Reply to comments made by Referee #1 on the manuscript: "Continuous in-situ monitoring of nitrate concentration in soils – a key for groundwater protection from nitrate pollution" by: Elad Yeshno

Figure 1 – Loam, sand and clay soil's retention curves (Filipovic et al., 2016). The dashed lines mark the matric potential for Loam at about 15 % water content, and which is about 900 cm (equivalent to ~880 mbar).

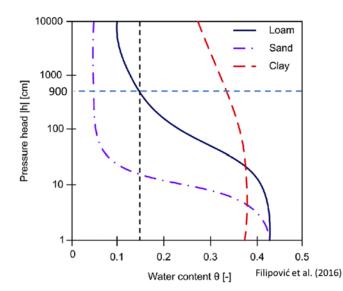
<u>Comment 1:</u> Continuous suction of pore-water from unsaturated porous medium (and bringing it up to surface in small diameter tubing) must impose some limitations of minimum water-content (soil-texture dependent) in which this apparatus can work (what suction pressures are imposed on the cups?). A TDT for water content monitoring was installed in the experimental setup, therefore I am sure the authors have some understandings considering the soil moisture conditions effects on the nitrate monitoring possibilities that are of interest for the HESS readership. Therefore, I encourage the authors to elaborate on this issue.

Reply to general comment 1: The efficiency of the nitrate monitoring system is indeed depended on its ability to extract a stream of soils solution, from the soil pores and into the sensor's optical flow cell. Accordingly, the system operation effectivity is depended upon the soil water potential. However, in agricultural soils, where the system is designed and intended to be installed, the water content is usually high enough to allow root uptake, and as such is sufficient enough to enable efficient operation of the monitoring system. Nevertheless, at low water content (water potential), as may happen between growing seasons or during dry periods, both water flow and nitrate transport is decrease dramatically, and consequently the potential for nitrate leachate out of the root zone to deep unsaturated zone is limited, thus reducing groundwater pollution potential. During the column experiments the hydraulic and suction parameter were set to represented typical agricultural soils condition for sandy loam, and were set to water content levels between 15 - 16.5 %. The porewater suction pressures levels were set between 600 - 800 mbar while typically the soil water pressure in these water contents is in the range of 830 - 950 mbar (Figure 1) (Filipović et al., 2016). The manuscript was revised accordingly to account for the soil water potential impact on the measurement efficiency (lines 181 - 186). The sampling tube diameter (1.9 mm) and length (<10 m) did not impose limitation to pore-water stream from the porous interface to the optical cell.
